Planning & Zoning Board

Thursday, September 21, 2023

1. App# 2023-5479; 1551 Ives Avenue; Marie's House of Hope Inc.; Conditional Use
2. App# 2023-5486; 7305 E. Main Street; Richard Holmes; Variance
3. App# 2023-5487; 7305 E. Main Street; Richard Holmes; Certificate of Appropriateness

**MINUTES REGULAR MEETING
REYNOLDSBURG PLANNING & ZONING BOARD
September 7, 2023**

SHEET TITLE:
FLOOR PLANS

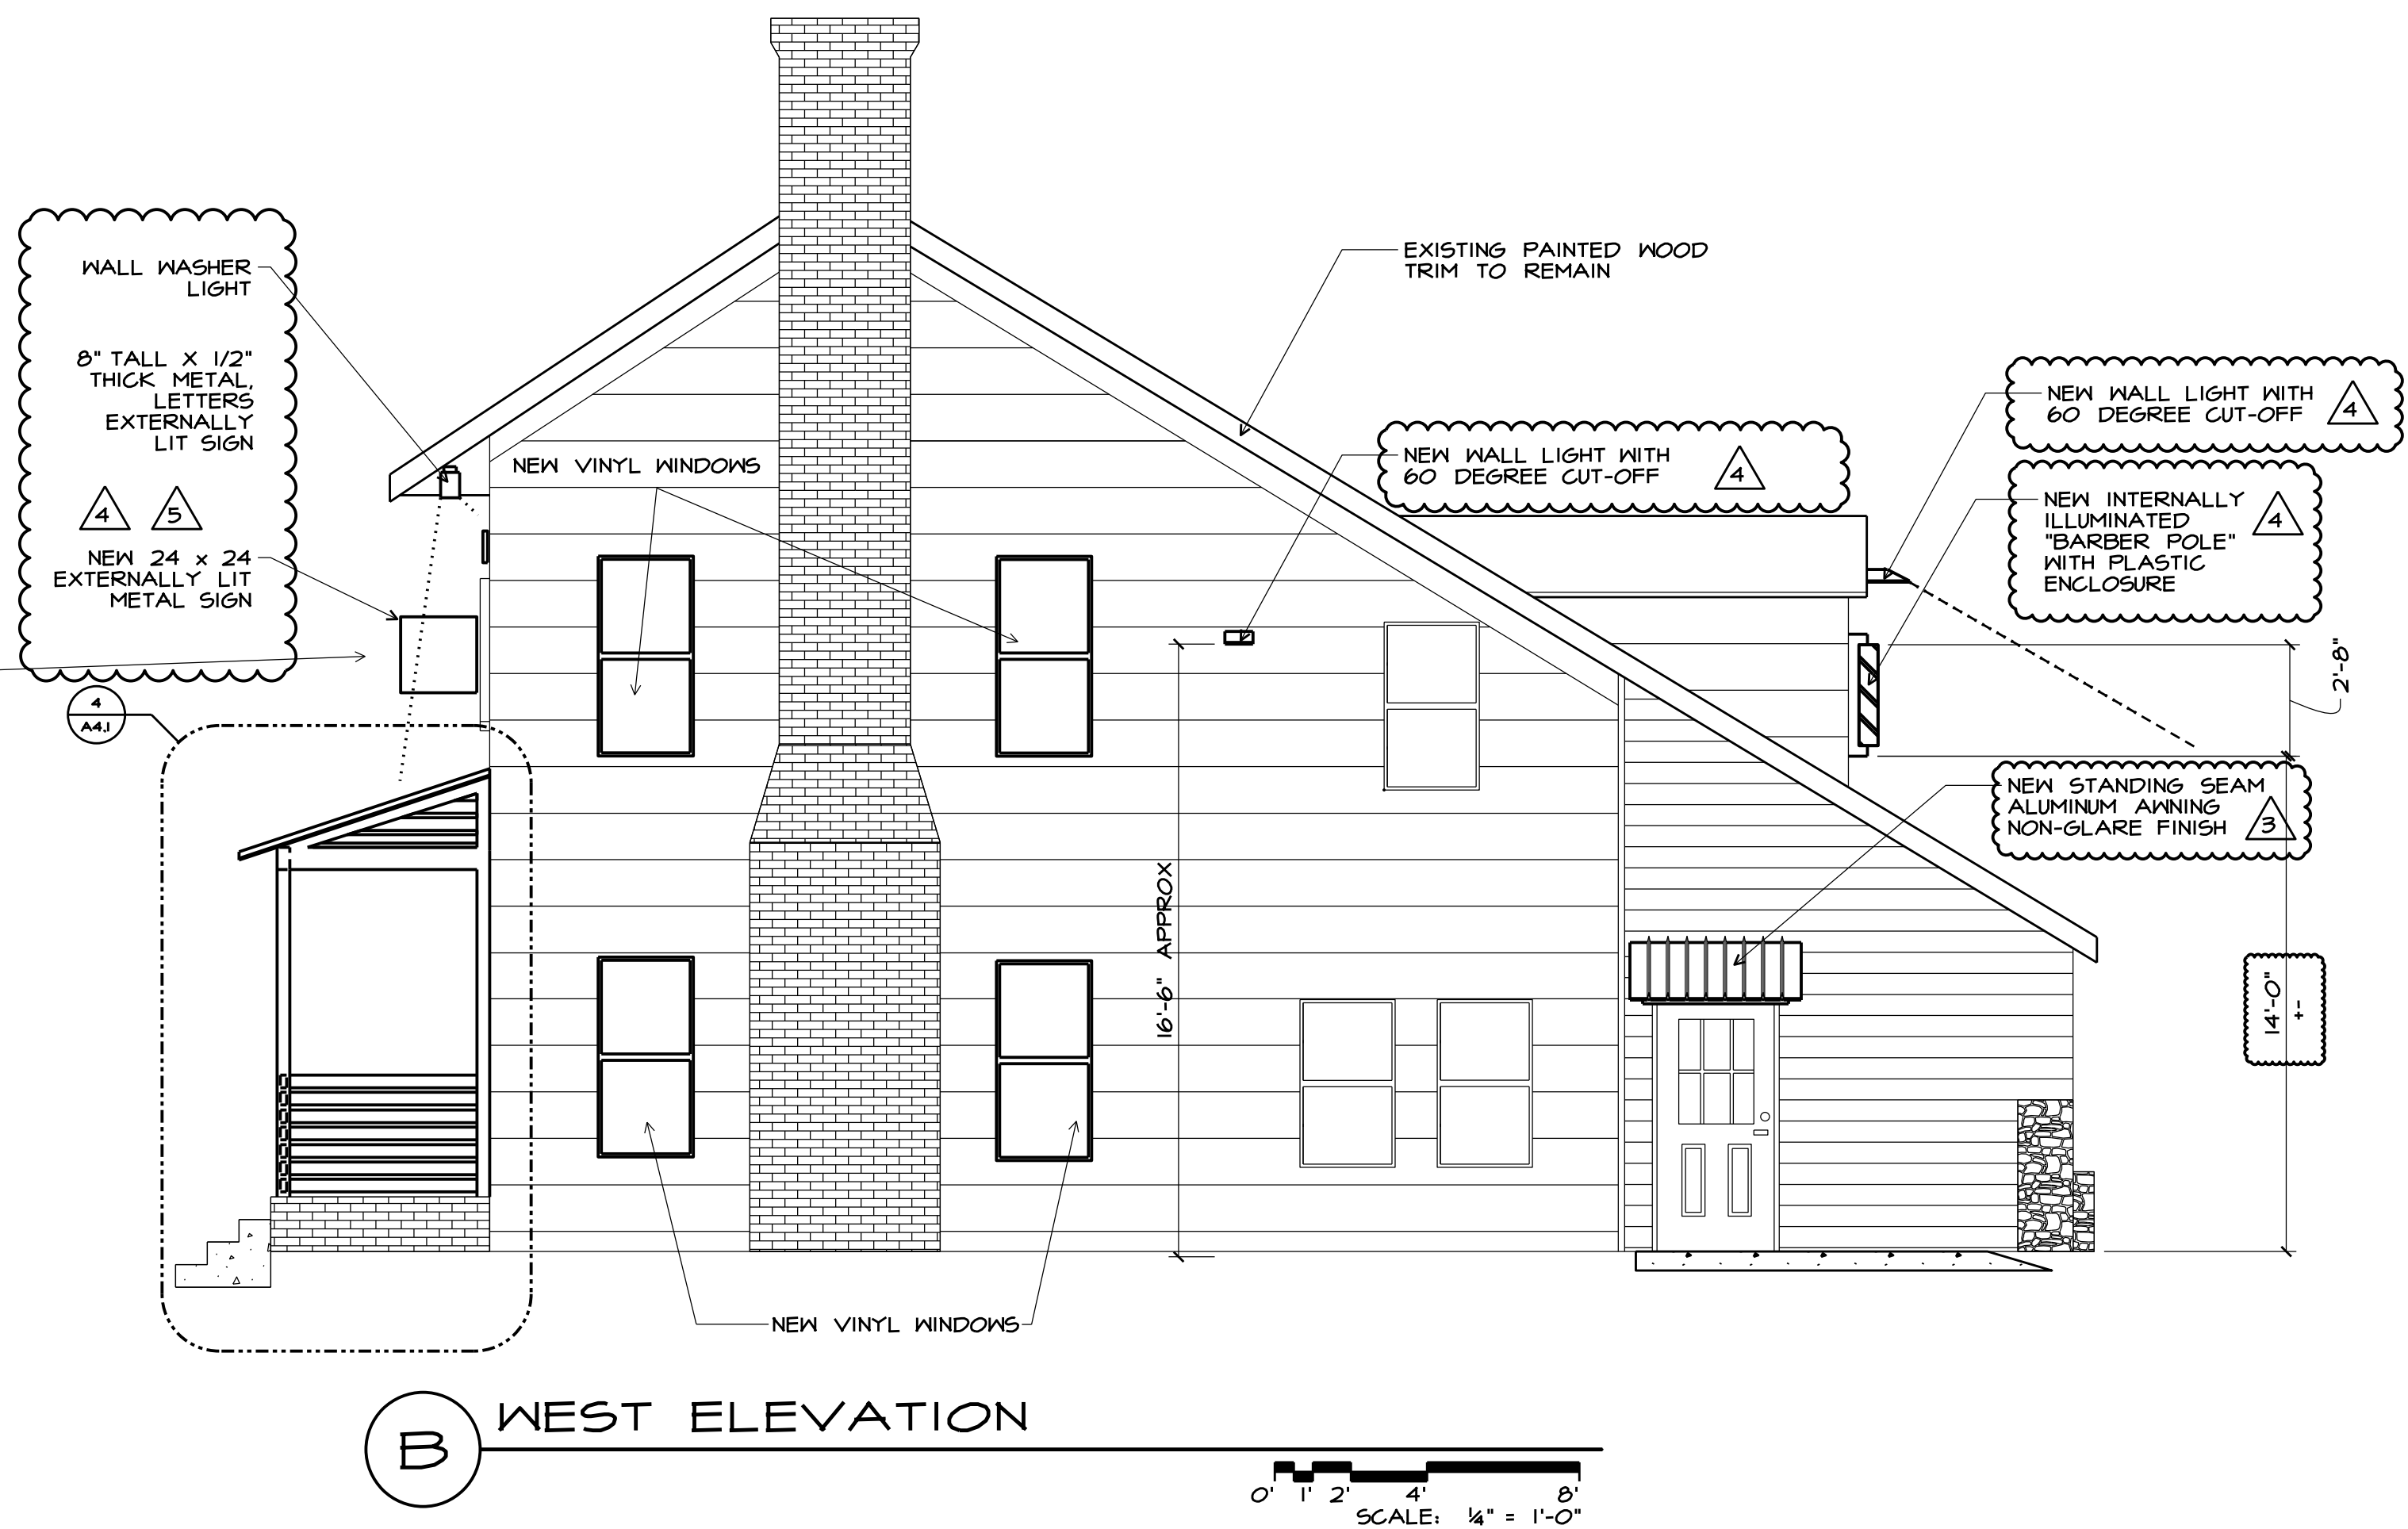
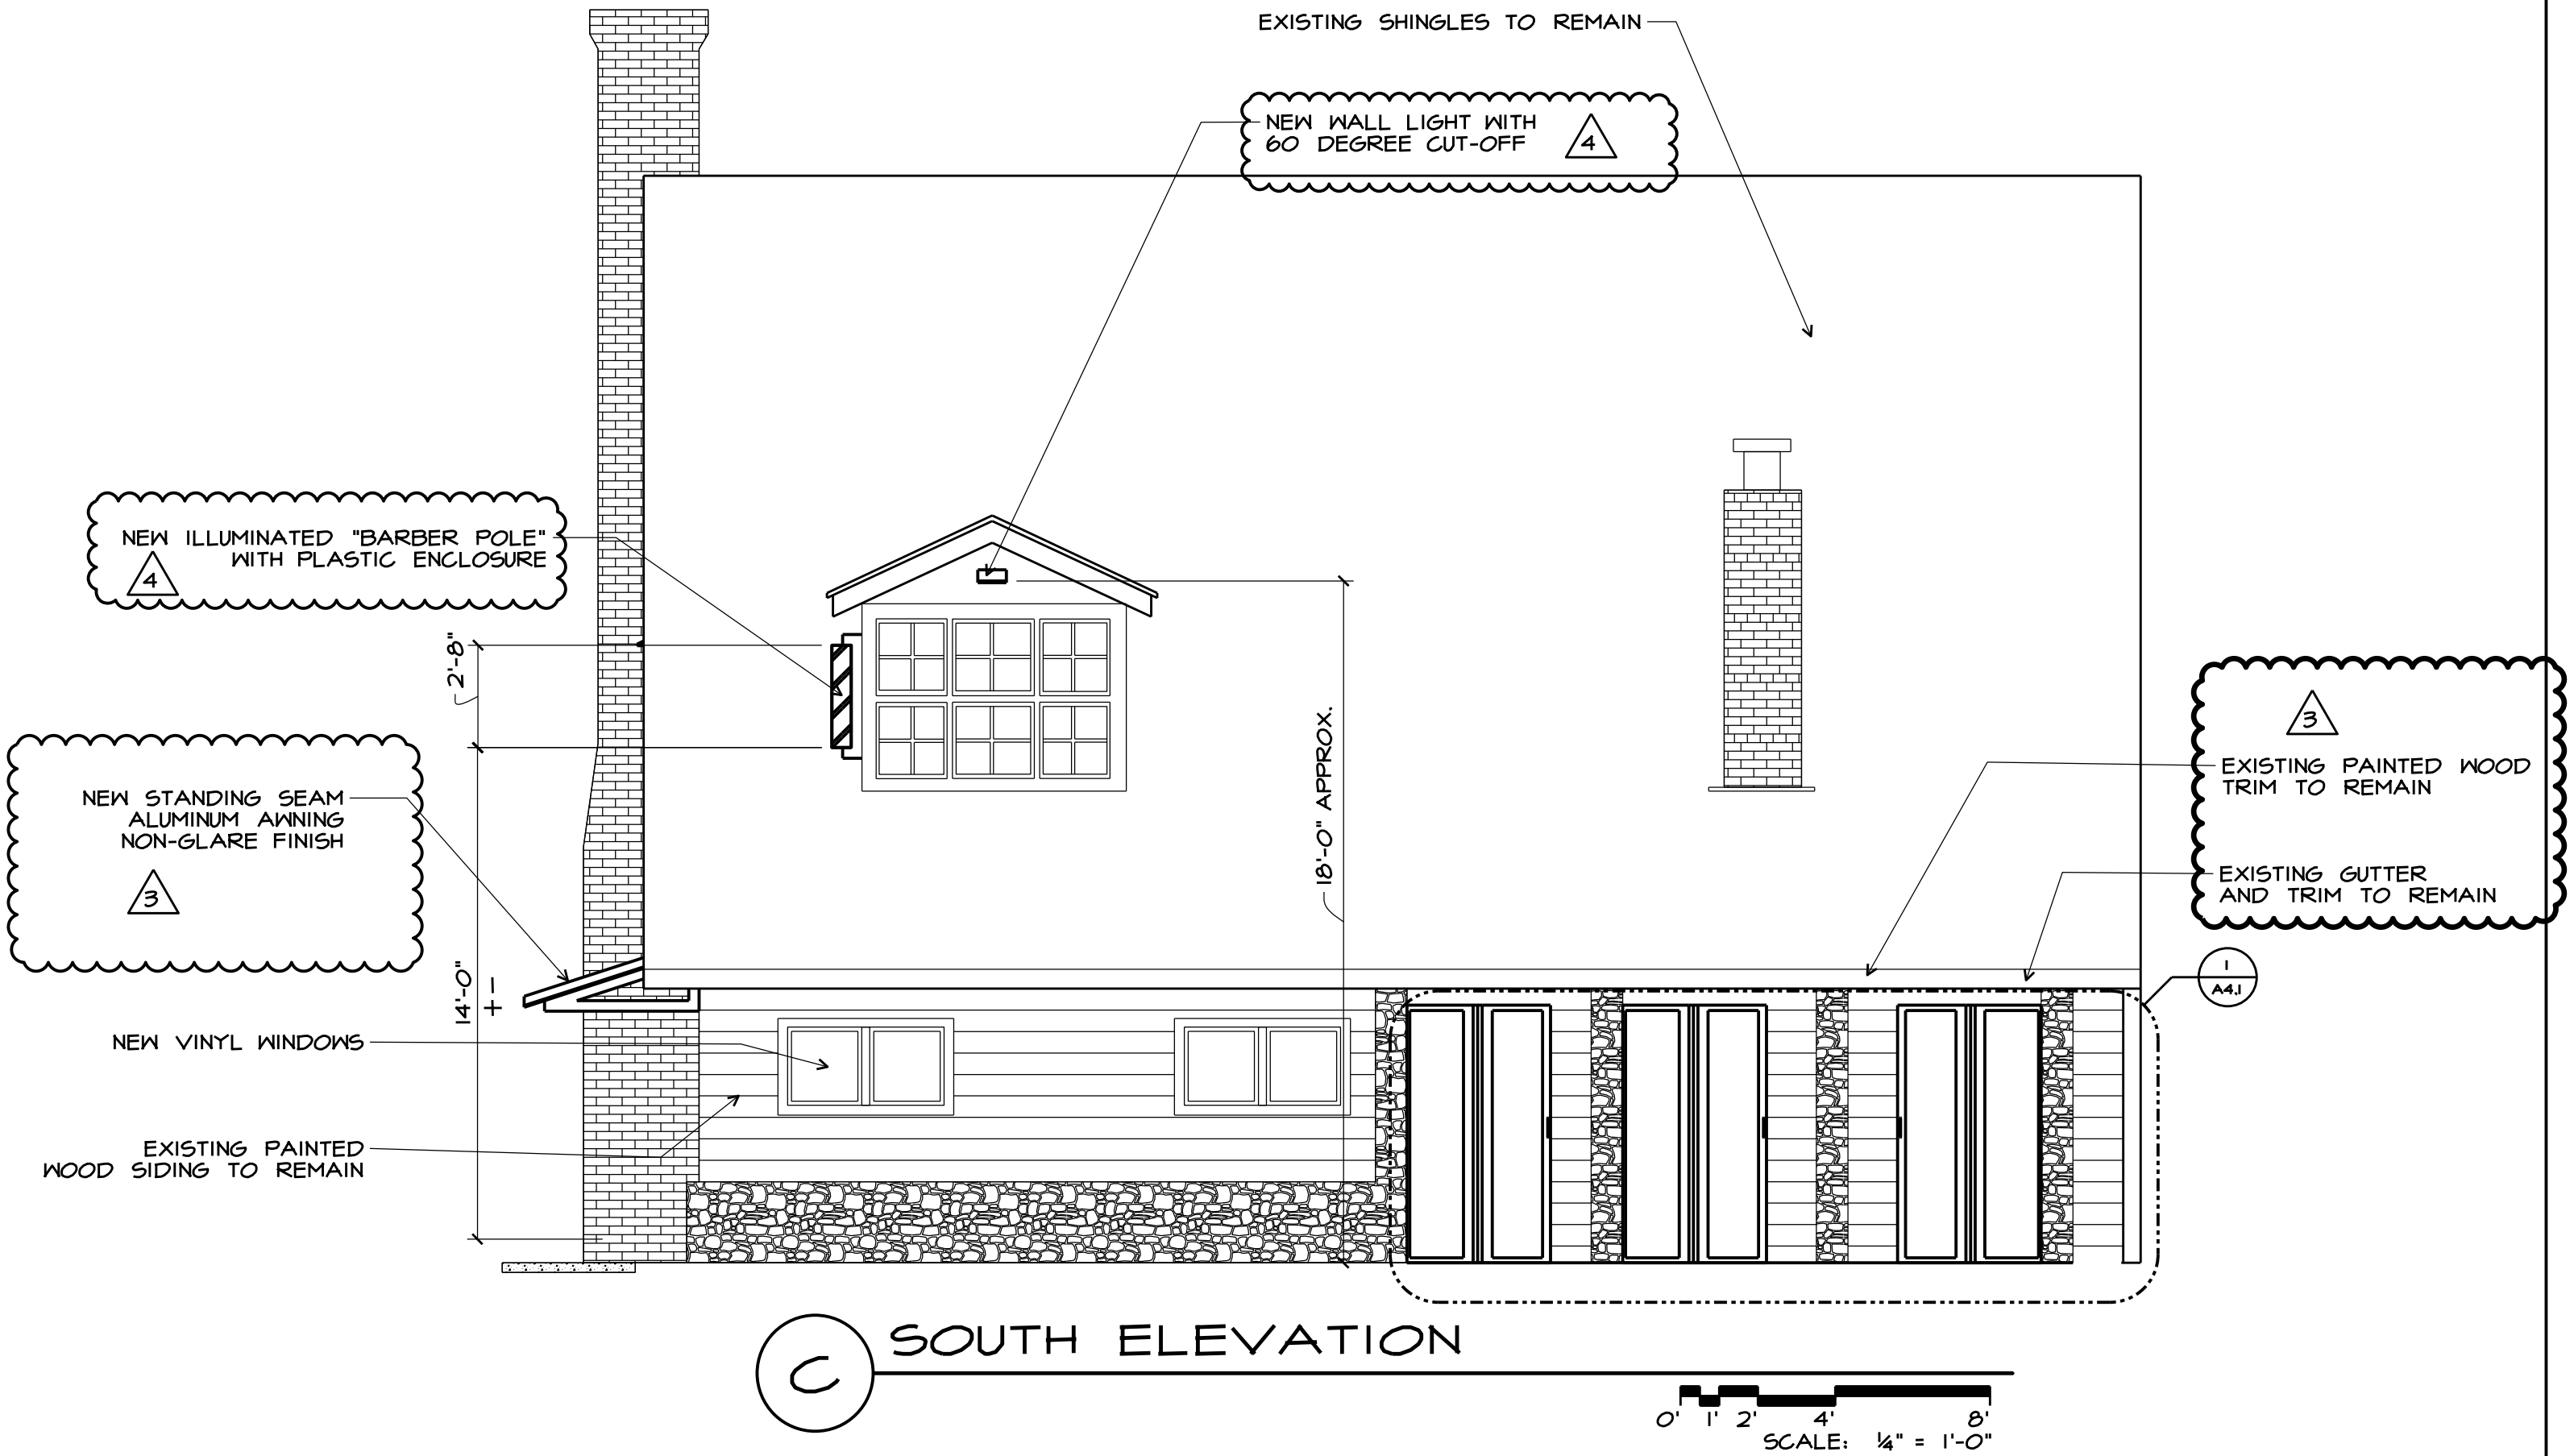
- a. No Plan B. Not provided on A-1.1. Not angled out on the sheets, needs to be clearly identified.
10. The sign plan states the sign is 48" by 48" for a total square footage of 16SF. The maximum square footage permitted of a projecting sign is 6 SF. Section 1105.03.C.v.2

- vii. Since the architectural drawings (Sheet A1.1) show the new porch overhang over the property line, into the public right-of-way, please provide a hold-harmless agreement with the City. Please have the City Attorney’s office deem the agreement sufficient, prior to a Certificate of Appropriateness being issued.
